Proposed development: Reserved Matters Application for Approval of the matters reserved by the Outline (Hybrid) planning permission ref: 10/20/0107 (Appearance, Landscaping, Scale and Layout) for the erection of 13no. Industrial units with associated landscaping and access to the land off Hollins Grove Street

**Site address:
Hollins Industrial Park
Hollins Grove Street
Darwen
BB3 1HG**

Applicant: Hollins Industrial Park Ltd

1.0 SUMMARY OF RECOMMENDATION

3.2.4 The proposed site layout plan is shown below:

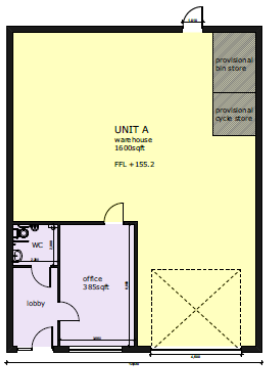
4.1.20 The proposal is assessed against the Class B2/B8 use applied for. The scheme makes provision for 40 off-road parking spaces (including 13 disabled bays) and includes a shared service yard. The proposed site layout plan ensures a vehicle can enter the site, can both turn in to and out of the site in both directions and manoeuvre easily and safely within the site, thus enabling all vehicles to enter and leave the site in a forward gear. Moreover, the scheme also makes provision for sufficient off-road parking; all unit blocks have sufficient space for occupiers of each unit to park and operate and are capable of receiving deliveries without restricting the free flow of vehicles entering and leaving the site. The scheme also includes a pedestrian walkway and crossing which enables safe internal movement on foot.

4.1.21 Subject to minor amendments to the layout, to improve pedestrian and cycle access within the site, and which can be secured by condition, the proposal is considered acceptable from a highway safety perspective, following review of the submitted layout by the Council's Highways consultee.

- 1) Please seek confirmation that the pedestrian refuge at the site access and the footway extension, dropped kerbs and tactile paving across the Network Rail access are to be provided as these do not appear on the site layout plan.
- 2) Please request a pedestrian/cycle entrance to the site from Hollins Grove Street in the Southwest corner of the site. Additional pedestrian routes should also be provided around the perimeter of the area of hardstanding to provide ease of access to the units to the East of the site from this access point. This will help to make the site more accessible for employees and visitors.

6. Prior to occupation of any of the units hereby approved, final layouts of pedestrian and cycle access routes within the site shall be submitted to the Local Planning Authority for approval, laid out in accordance with the approved details and thereafter permanently retained.
